## REACTIVITY CONTROL SYSTEMS

### 3/4.4.9 PRESSURE/TEMPERATURE LIMITS

Figure 3.4-4

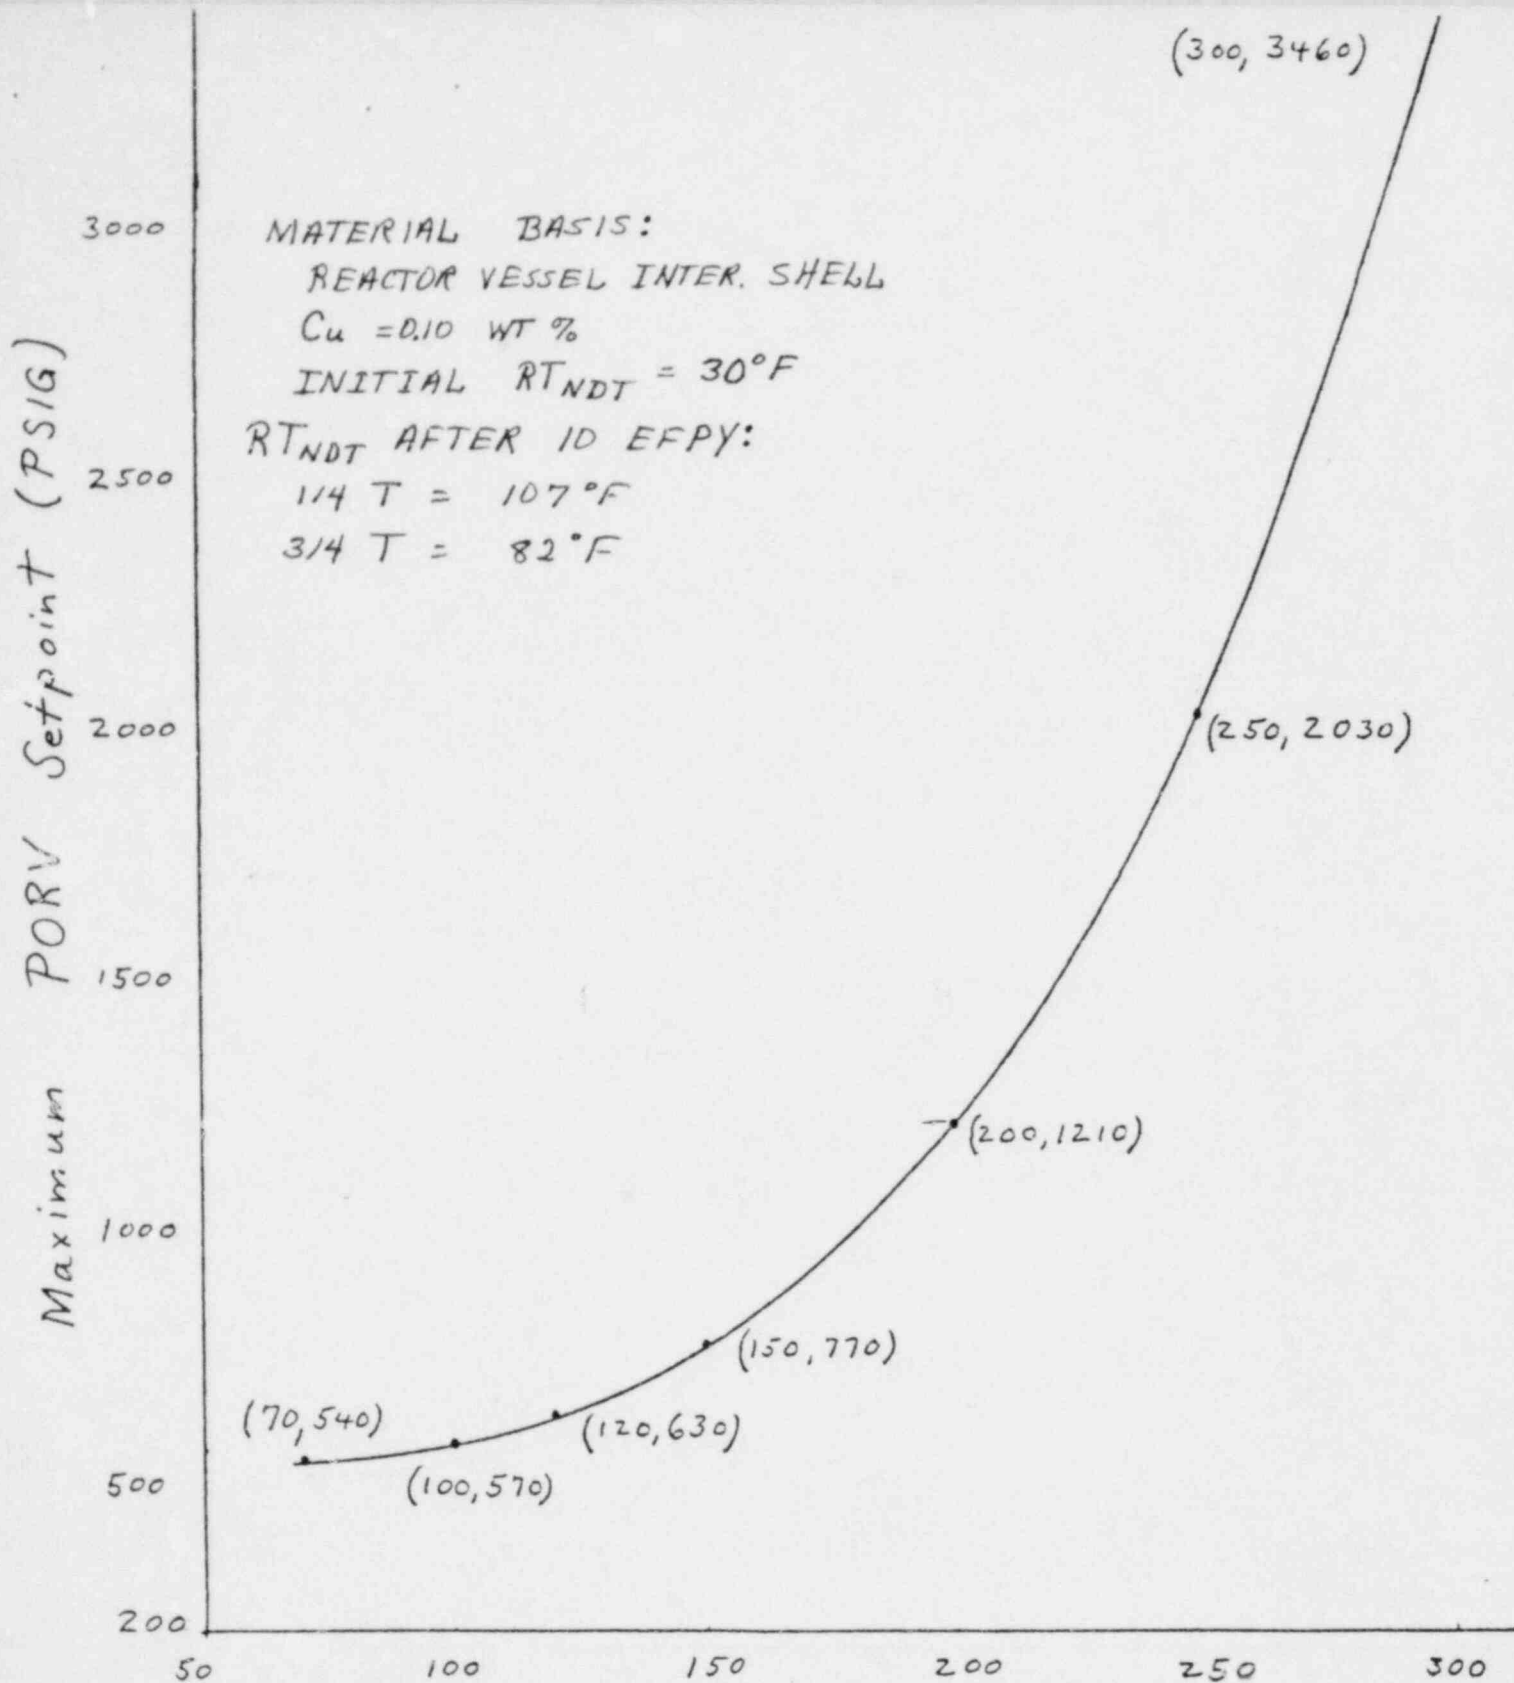
- a. Two power operated relief valves (PORVs) with a lift setting of less than or equal to ~~505 psig~~, *or the maximum setpoint defined by Figure 3.4-4, or*
- b. The Reactor Coolant System (RCS) depressurized with an RCS vent of greater than or equal to 2.7 square inches.

APPLICABILITY: MODE 4 when the temperature of any RCS cold leg is less than or equal to ~~275°F~~, *300°F*, MODE 5, and MODE 6 with the reactor vessel head on.

- ~~b. With both PORVs inoperable, depressurize and vent the RCS through at least a 2.7 square inch vent(s) within 8 hours.~~
- a. ~~g.~~ In the event either the PORVs <sup>becomes inoperable,</sup> or the RCS vent(s) are used to mitigate a RCS pressure transient, a Special Report shall be prepared and submitted to the Commission pursuant to Specification 6.9.2 within 30 days. The report shall describe the circumstances initiating the transient, the effect of the PORVs or vent(s) on the transient and any corrective action necessary to prevent recurrence. *of the inoperability, plans for restoring inoperable PORVs to OPERABLE status, cause*
